# MAX32672 ERRATA SHEET

## Revision B2 Errata

Figure 1. MAX32672 LDO Solution with MAX8516

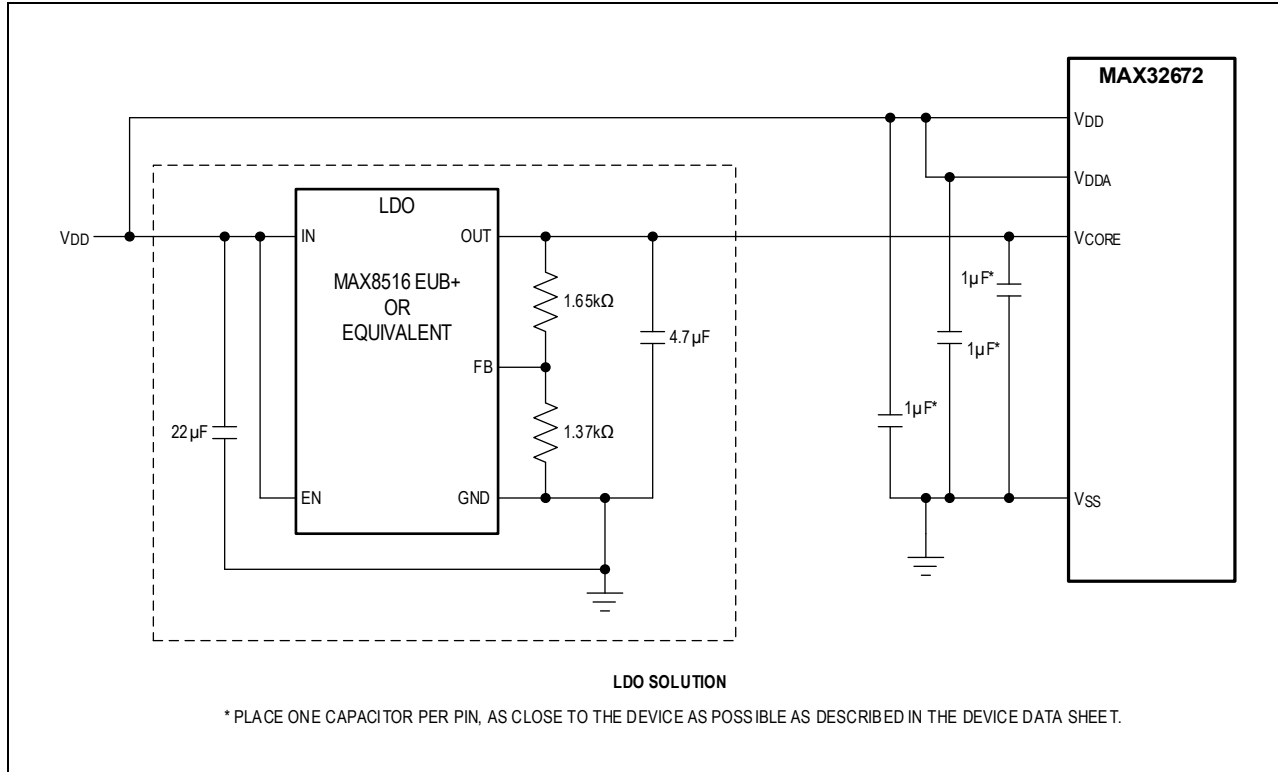
### 2) MEMORY MAY BE CORRUPTED DURING POWER-DOWN WHEN OPERATING IN DUAL-SUPPLY MODE

Incorrect sequencing of the  $V_{DD}$  ( $V_{DDA} = V_{DD}$ ) and  $V_{CORE}$  supplies can corrupt the flash memory contents.

- Control the power supplies so that:
  - $V_{CORE} \geq V_{CORE(MIN)}$  before  $V_{DD} > V_{RST(VDDMIN)}$  on power up
  - $V_{DD} < V_{RST(VDDMIN)}$  before  $V_{CORE} \leq V_{CORE(MIN)}$  on power down
- RSTN is asserted active whenever  $V_{CORE} \leq V_{CORE(MIN)}$ .

Workaround #1 can be implemented using an LDO such as the MAX8516 or equivalent, as shown in [Figure 1](#). The LDO is guaranteed to regulate its output, which drives  $V_{CORE}$  well below  $V_{RST(VDDMIN)}$ .
